Access Compliance Report Public Rights-of-Way (Curb Ramps)

Intersection ID: 24292 Main Street: MICHAEL_LYNN_RD Cross Street: WRIGHT'S_FERRY_RD Location: S

ADA ID: 14FF87F23AAC Ramp Type: BlendTrans2 Initial Pass/Fail: Pass Overall Compliance: No Severity Score: 10

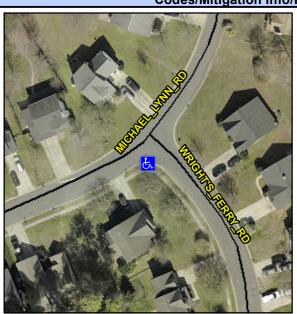
Remove & Replace Curb Ramp With Two New Directional Ramps or Equivalent.

Not Found, R305

No

Curb Slope (%)

10.8
